MAC SDU Fragmentation & Packing scheme for 16m

Document Number: C80216m-09_0393

CR to SDD as per configuration control procedure (80216m-09_0008)

Discuss and approve the proposed text changes into SDD document

Figure x: Fragmentation & Packing Extended header for 16m

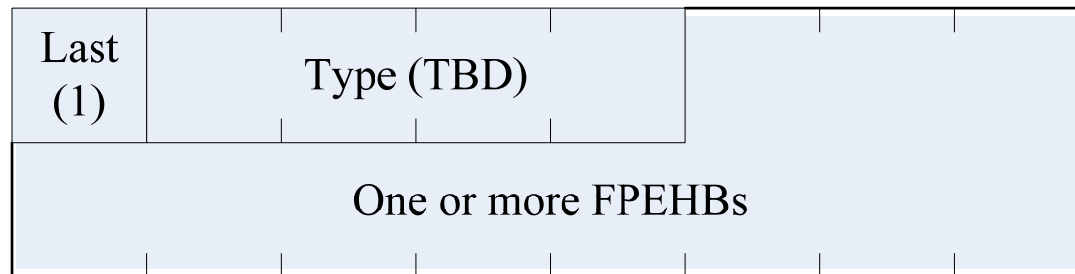
[Insert the following text in section 10.12.2.1 in IEEE 802.16m-08/003r7]

IEEE 802.16m supports fragmentation of MAC SDU into one or more MAC PDUs and also allows the packing of one or more SDUs/SDU fragments in a single MAC PDU. The fragmentation and packing extended header is shown in figure x. FPEH is the last extended header present in the MAC PDU. FPEH consists of one or more Fragmentation and packing extended header blocks (FPEHBs). The number of FPEHB in FPEH is equal to number of flow payloads in the MAC PDU, which need fragmentation & packing info. Number of flow payloads which need fragmentation and packing info are present before other flow payloads, in a multiplexed MAC PDU.

Figure y: Fragmentation & Packing Extended Block

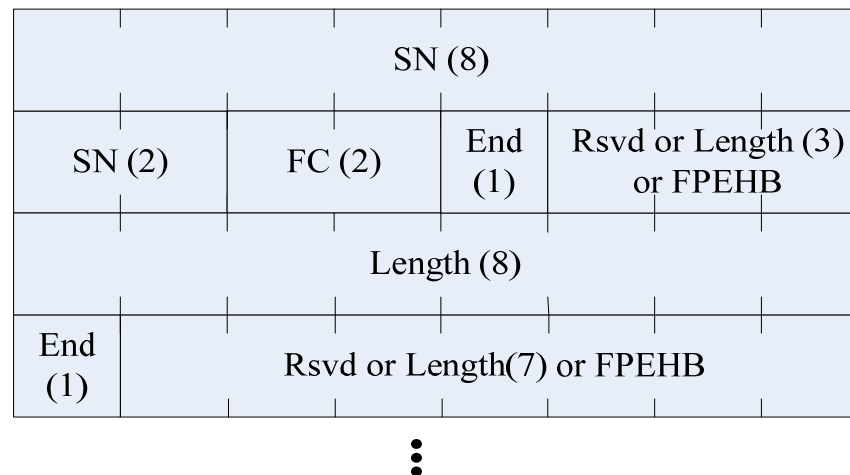
The fragmentation and packing extended header block is shown in figure y.

- SN : Payload sequence number
- FC : Fragmentation Control Bits definition are given in table y.
- End = 1: If this is the last FPEHB in FPEH, Rest bits for byte alignment of FPEH are reserved.
If this is not the last FPEHB in FPEH, another FPEHB follows after the End bit.
- End = 0: Length and another End field are followed
